3 July 2015

Our Ref: 14094

RE: PANEL REFERENCE: 2014SYE145 DA: 6 - 8 CRANBROOK ROAD, BELLEVUE HILL

Figure 1: Site plan also showing area of road reserve subject to negotiation to purchase (shaded orange)

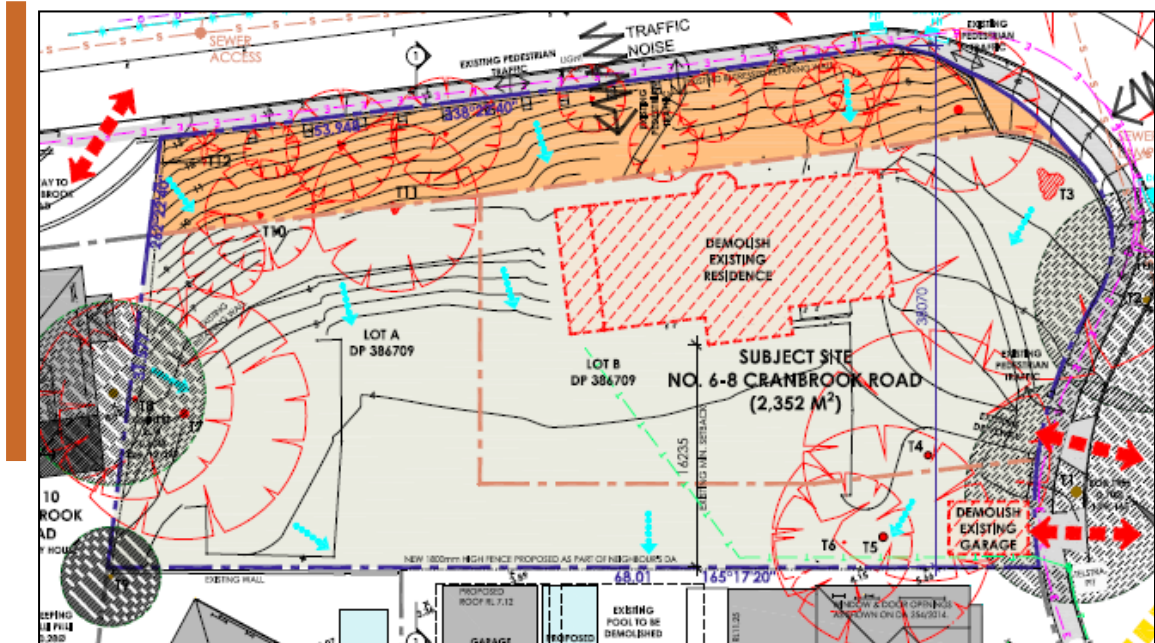
Lots A and B in DP 386790 when combined provide for a site area of about 1,932m². However, our client is negotiating with Council to purchase a portion of the Cranbrook Road road reserve (of about 423m²) which is defined by a sandstone retaining wall and landscaped embankment. The area the subject of those negotiations is shown on Drawing A010, an extract of which is provided below:

The application does propose works within that part of the road reserve, namely to modify the embankment and construct a series of retaining walls and undertake associated landscape works and boundary fencing. However those works, and the road reserve land, are not essential elements of the proposal, and could be excised from the project if the purchase were not to proceed.

Given that, we contend that the process for the purchase of this portion of the road reserve is not something that must be finally resolved before consent could operate. In support of this position we note:

We therefore request the JRPP **delete** the proposed "deferred commencement" condition and instead allow this matter to be the subject of a condition to be satisfied prior to the issue of a Construction Certificate. Our suggested wording for such a condition is provided below:

1. Complete and lodge Council form "Application to formalise an existing encroachment on Council Land". An Application fee is payable **and**;
2. The encroaching structures must be formalised by:
 - (a). The Subdivision of the road reserve to excise the area encroached upon, closure of the road parcel and Sale of the land to the owner of 6-8 Cranbrook Road **OR**;
 - (b). Enter into an easement agreement with Woollahra Council under Section 181(a) Conveyancing Act 1919 permitting the permanent structures within the road reserve to remain for the life of the building or the redevelopment of the structure or the site, whichever occurs first.

Figure 3: Floor space the subject of condition C.1(j) - floorplan

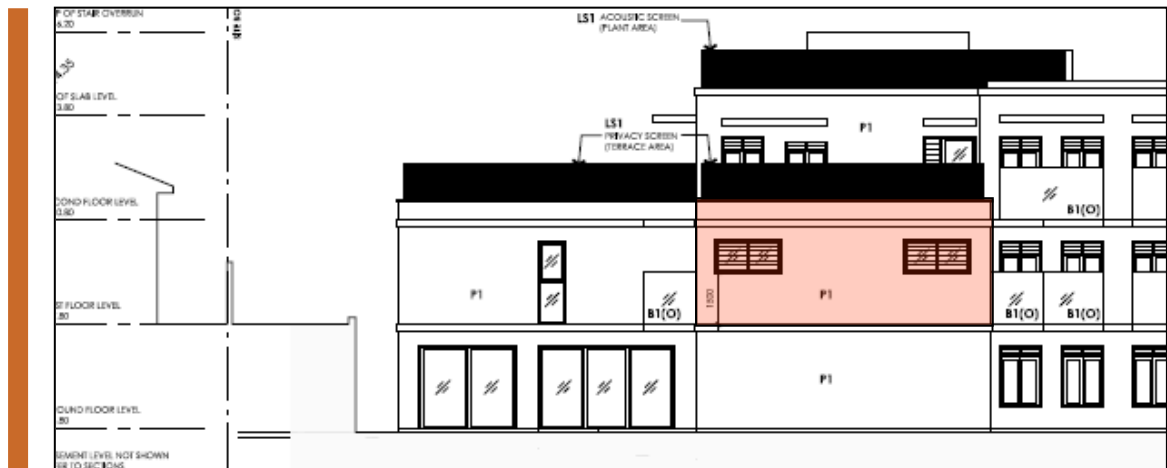
"The south-eastern corner of the building (in the location of rooms 35 and 36) on the first floor level is to be setback a minimum 10.5m from the eastern boundary and align with the eastern elevation wall of rooms 37-41. The roof terrace on the second floor level is to be setback a corresponding amount (minimum of 10.5m from the eastern boundary). The roof above the ground floor may contain landscaping but must be non-trafficable and only accessible for maintenance purposes."

We understand the intention of this condition to remove building volume relative to the eastern boundary to address amenity considerations. The floor space in question is highlighted on an extract from Drawing A112 and A402 below.

We do not agree that such a design modification is necessary, and request the JRPP **delete** the proposed condition. In support of this request we provide the following contentions:

- The matter was never raised with our client throughout the assessment of the application.
- This matter was not a part of condition C.1 of the assessment report lodged with the JRPP. It was only added following consideration of the application by Council's Development Control Committee on 15 June 2015, and subsequently by full Council at its meeting on 22 June 2015.
- Rooms 35 and 36 generally align with the existing garage at the rear of No. 4 Cranbrook Road.
- Rooms 35 and 36 are setback 5.7m from the eastern site boundary, being the common boundary with No. 4. The eastern wall of those two rooms is only 8.4m long. The ceiling of rooms 35 and 36 is only 6.8m above existing ground level at that boundary.

We request that this condition be deleted.
